Service Bulletin

NO: HIFI2-99-007

SUBJECT: UNIT RANDOMLY POWERS ON, CYCLES MD DISC TO LOAD/EJECT, RECORD FUNCTION DISABLED

MODEL (S): MDS-S38/S39/JE320/JE500/JE510

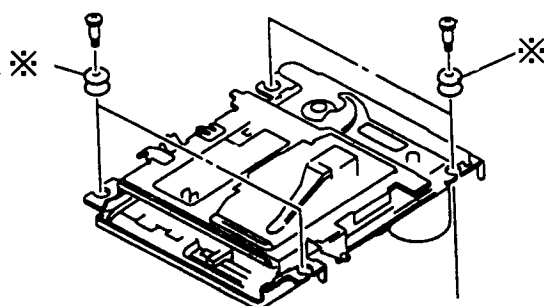
Solution: Replace the following components with the improved versions. (Perform the upgrade on sets with applicable serial numbers regardless of the customers symptom.)

REF	FORMER		NEW	
	DESCRIPTION	P/N	DESCRIPTION	P/N
*	INSULATOR	4-987-327-01	INSULATOR	4-987-327-01
S681	PUSH SWITCH (1 KEY)	1-572-467-61	PUSH SWITCH (1 KEY) LIMIT IN	1-572-467-21
S685	PUSH SWITCH (1 KEY)	1-572-467-61	PUSH SWITCH (1 KEY) CHUCKING IN	1-572-467-21
S686	PUSH SWITCH (1 KEY)	1-762-621-21	PUSH SWITCH (1 KEY) PACK OUT	1-762-621-21
S688	PUSH SWITCH (1 KEY)	1-762-621-21	PUSH SWITCH (1 KEY) REC POSITION	1-762-621-21
